Instrument: WTS-LV

Subject: Lubricating Threaded Pin on Cable Clamp T-Handle

*Figure 1: Applying lubricant t-nut and bolt threads*

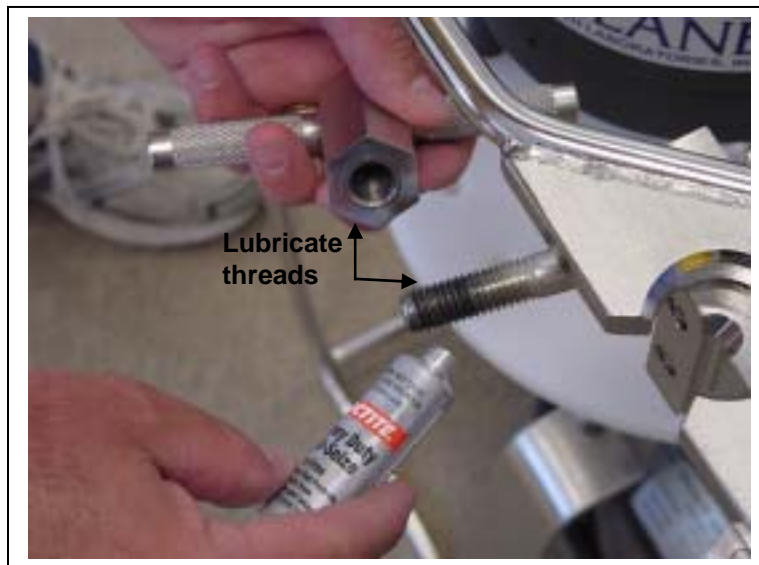
**Summary:** Tightening and loosening the WTS-LV cable clamp without lubricating the T-nut can cause galling. If the T-nut galls, the clamp is unusable.

**Resolution:** To minimize risk of galling, apply a small amount of Metal-Free Anti-Seize lubricant (included in the WTS-LV toolkit) to the T-nut and bolt threads (as shown in Figure 1), and hand tighten the clamp (do not overtighten). Tools are not required to tighten the clamp on the wire.
